## HISTORIC AND DESIGN REVIEW COMMISSION

October 20, 2021

**HDRC CASE NO:** 2021-469  
**ADDRESS:** 314 NORTH DR  
**LEGAL DESCRIPTION:** NCB 7014 BLK LOT E 12.5 FT OF 27 & W 44.5 FT OF 28  
**ZONING:** R-6, H  
**CITY COUNCIL DIST.:** 7  
**DISTRICT:** Monticello Park Historic District  
**APPLICANT:** Rudy Davila/DAVILA CONCRETE CONTRACTORS  
**OWNER:** BRITTNEY ESPINOZA/ESPINOZA BRITTNEY RYANNE &  
**TYPE OF WORK:** Installation of a driveway, curb cut, approach and on site walkways  
**APPLICATION RECEIVED:** October 14, 2021  
**60-DAY REVIEW:** Not applicable due to City Council Emergency Orders  
**CASE MANAGER:** Edward Hall

The applicant is requesting a Certificate of Appropriateness for approval to install a new curb cut, driveway apron, driveway and walkway on site at 314 North, located within the Monticello Park Historic District.

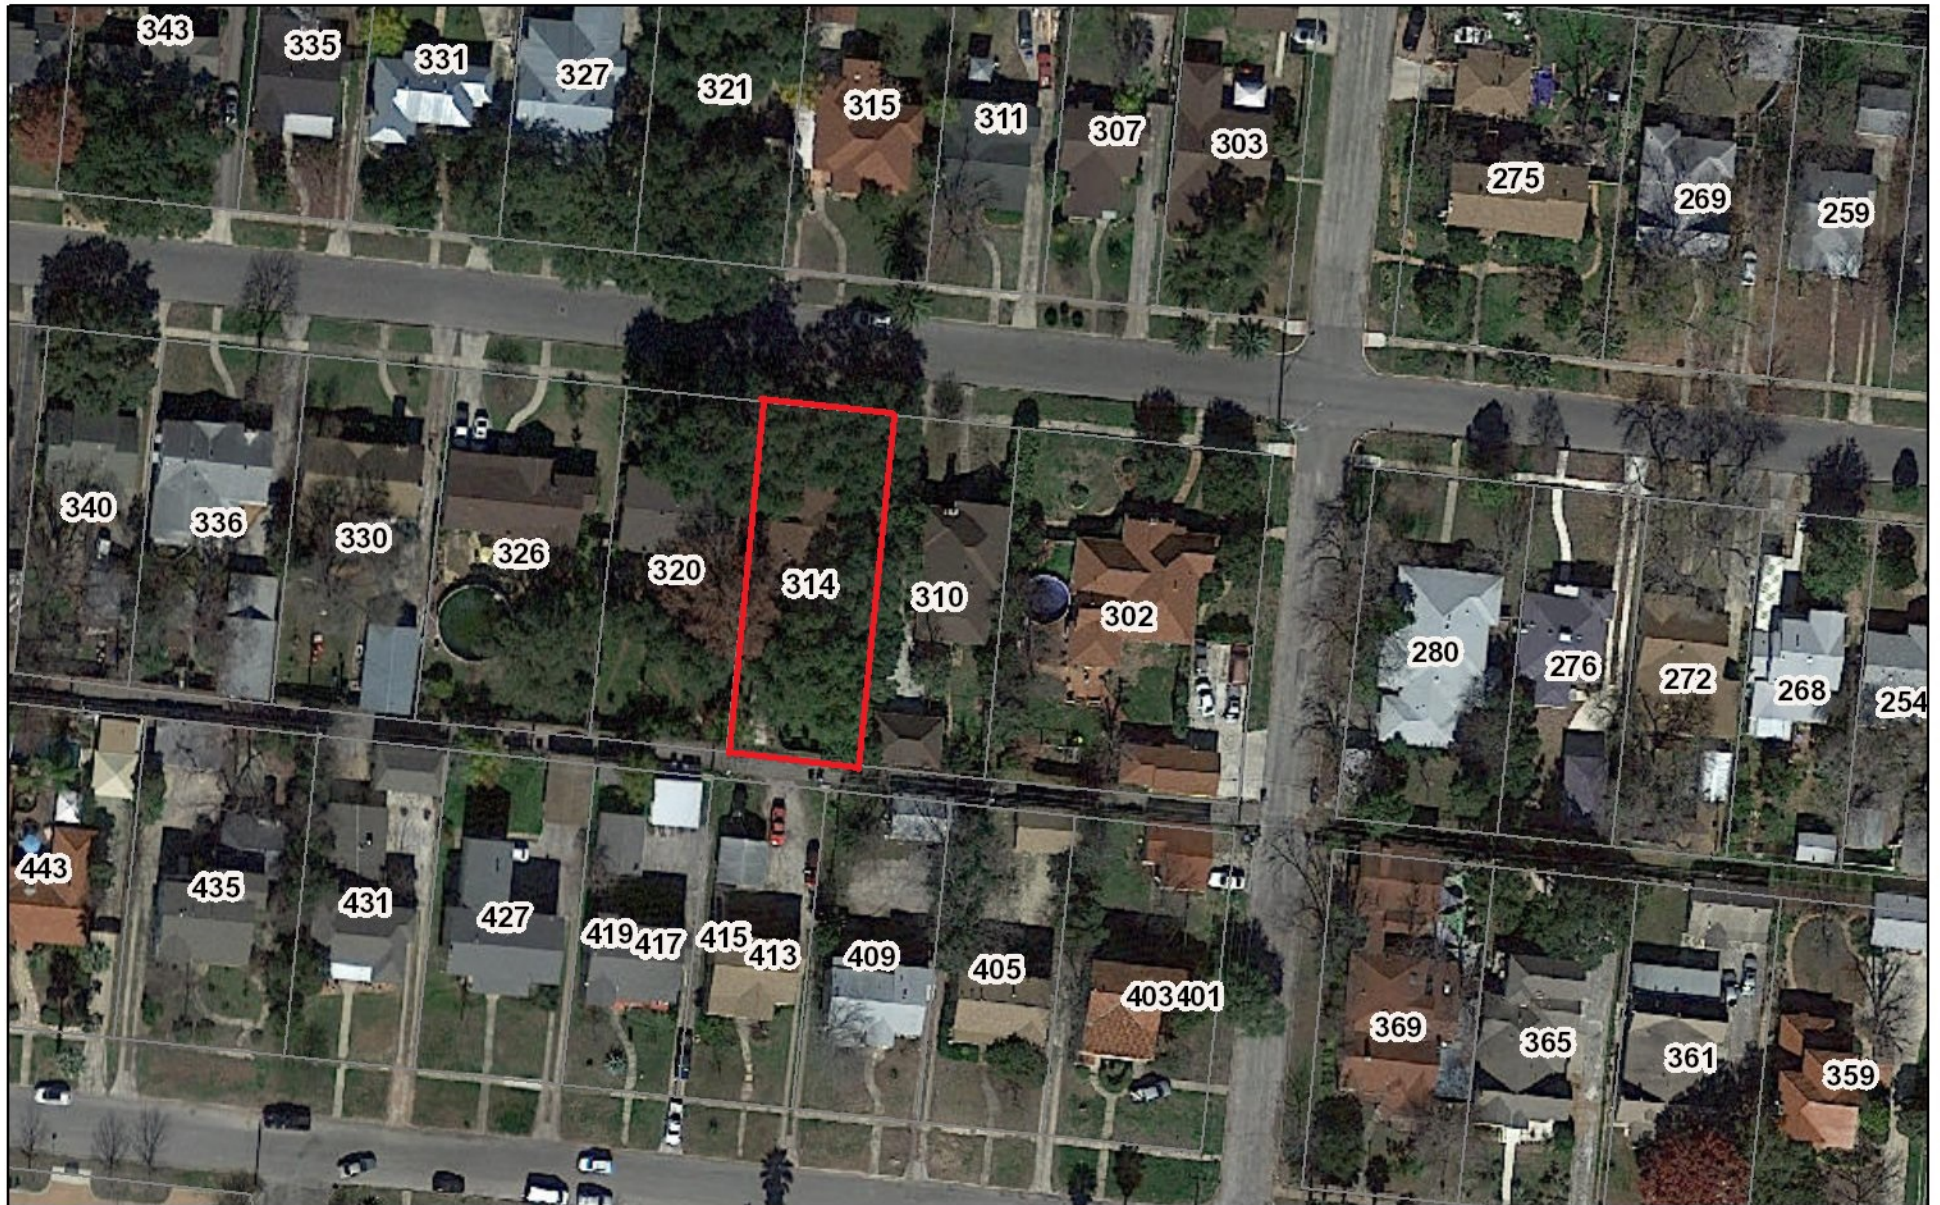
- d. DRIVEWAY – The applicant has proposed a driveway with a curved profile resulting a parking being located in front of a portion of the historic structure that is setback from the primary façade. The Guidelines for Site Elements 5.B.i., new driveways should feature a similar configuration as those found historically within the district in regards to their materials, width and design. Driveways found historically within the Monticello Park Historic District feature straight profiles with either ribbon strip or full concrete configurations. Historic driveways are approximately ten (10) feet in width. Staff finds the proposed driveway to be inconsistent with the Guidelines. Staff finds that a straight driveway that does not exceed ten (10) feet in width would be appropriate. While the driveway would terminate in front of the house, the section of the house where it would terminate is setback from the primary façade. Staff finds this terminating point to be appropriate.

- e. WALKWAY – The applicant has proposed a walkway within the front yard to feature concrete paving to lead from the proposed driveway to the existing front walkway. Staff finds the proposed walkway to be appropriate.

Staff recommends approval based on findings c and d with the following stipulations:

- i. That the proposed driveway feature a straight profile and a width that does not exceed ten (10) feet.
- ii. That the proposed curb cut and driveway apron be consistent with those found historically on the block in regards to profile and width.
